QC Call: Lake not hydro-flattened correctly (FID 3 in Errors shape file)

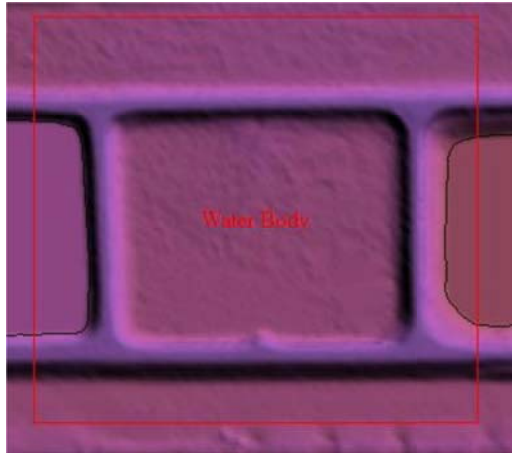
QC Call: River not connected where bridge was removed (FID 2 in *Errors* shape file)

QSI Response: Hydro breakline was improperly collected. We **will correct** the breakline attribution, as well as connect the features through the bridge. This will show a continuous double line drain feature, with monotonic elevations. The raster DEM and Contours will be regenerated to show the change to the final bare earth surface.

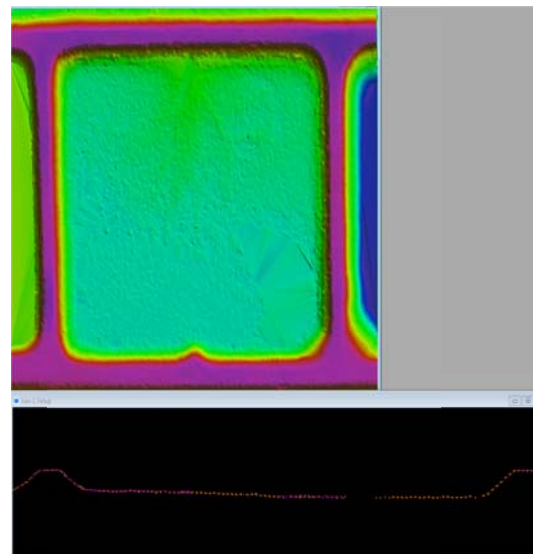
QC Call: Center Lake not hydro-flattened (FID 0 in *Errors* shape file)

QSI Response: The water body at time of LIDAR collection is less than 2 acres in size. The points to the immediate north of the water feature show elevation change to the magnitude of 1-2'. This feature **will not be collected** because it is inside of the collection specifications for hydrographic features.

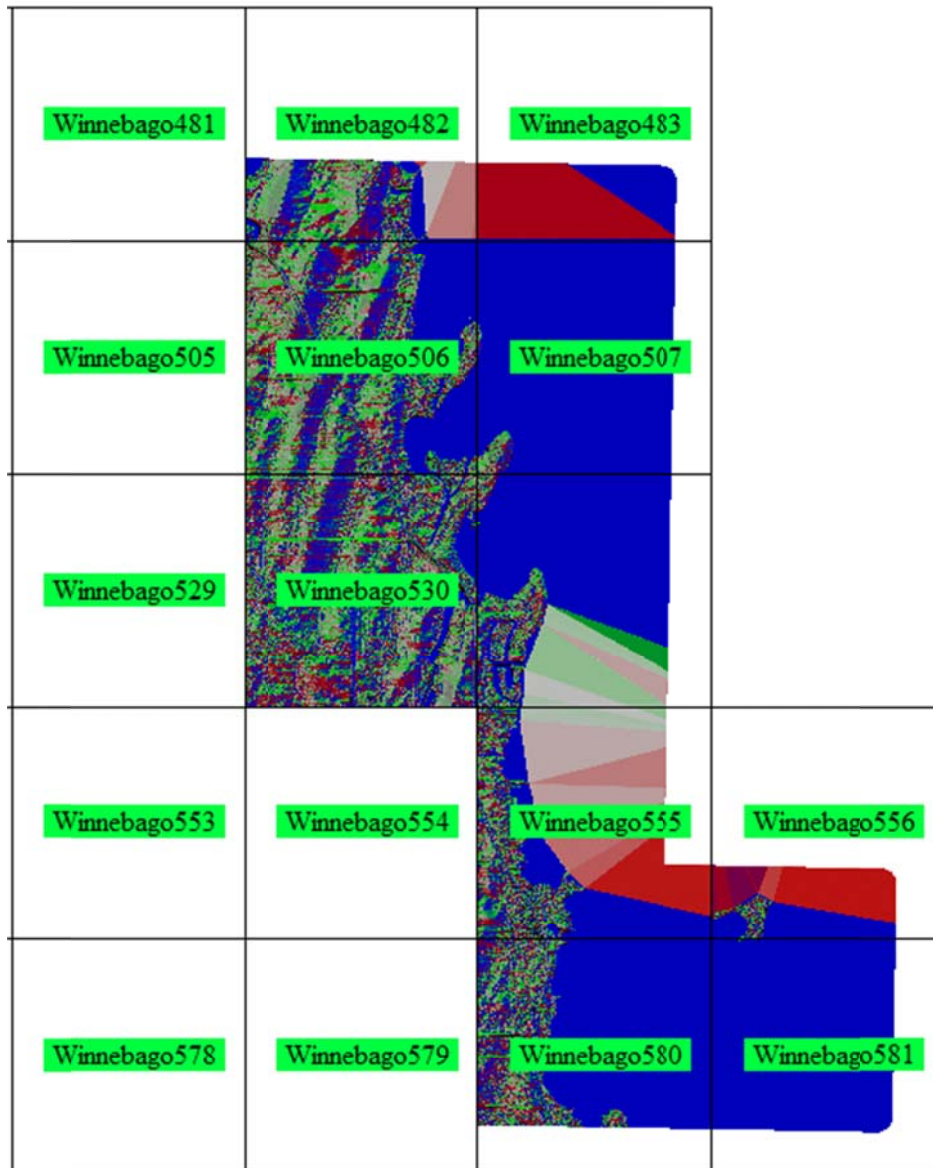
QC Call: Water body not hydro-flattened (FID 1 in *Errors* shape file)

QSI Response: As the intensity image suggests, LIDAR data voids delineate the presence of a water body that is at least 2 acres in size. **We will collect** a Lake_Pond breakline feature at a consistent elevation. The raster DEM and Contours will be regenerated to show the change to the final bare earth surface.
